# Thor 21 Fed Com 704H 30-025-42816

# EOG Resources, Inc Surface Location: Sec. 21, T. 26S, R. 33E Conditions of Approval

## See below for the conditions of approval for the multi-bowl wellhead system.

10-3/4" X 7-5/8" X 5-1/2" FBD-100 WELLHEAD SYSTEM QUDTE # - 93482

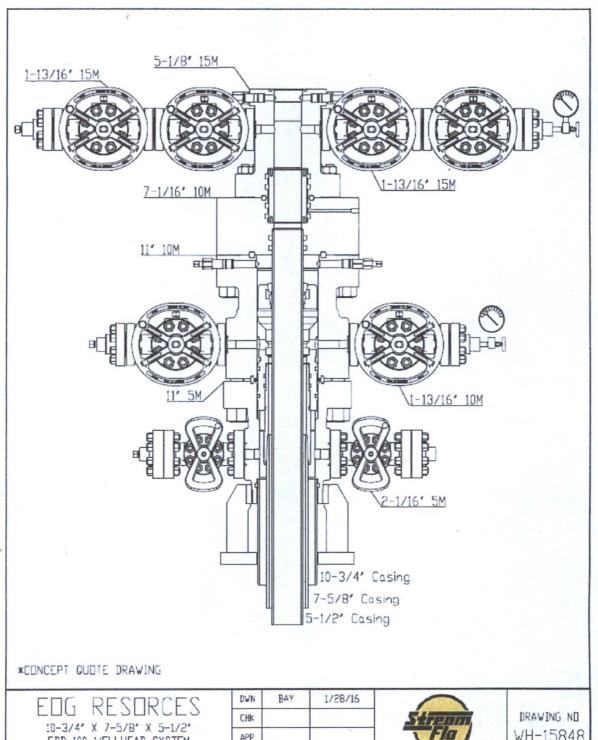
- 2. Operator has proposed a **multi-bowl wellhead assembly**. This assembly (BOPE/BOPE) will be tested when installed on the surface casing. Minimum working pressure of the blowout preventer (BOP) and related equipment (BOPE) required for drilling below the surface casing shoe shall be **5000 (5M)** psi.

- a. Wellhead shall be installed by manufacturer's representatives, submit documentation with subsequent sundry.
  - b. All BOP equipment will be tested utilizing a conventional test plug. Not a cup or J-packer type.

- c. If the welding is performed by a third party, the manufacturer's representative shall monitor the temperature to verify that it does not exceed the maximum temperature of the seal.

- d. Manufacturer representative shall install the test plug for the initial and all BOP testing.
  - e. Prior to running the intermediated casing, the rams will be changed out to accommodate the 7-5/8" casing. After installing the intermediate casing the casing rams will be removed and replaced with variable bore rams.

- Operator has broken a seal on the BOP stack therefore per Onshore Oil and Gas
  Order No. 2 the entire BOP stack shall be tested prior to drilling out the
  intermediated casing.

- a. A solid steel body pack-off will be utilized after running & cementing the intermediate casing. After installation of the pack-off and lower flange will be pressure tested to 5000 psi.

- b. If the cement does not circulate and one inch operations would have been possible with a standard wellhead, the well head shall be cut off, cementing operations performed and another wellhead installed.
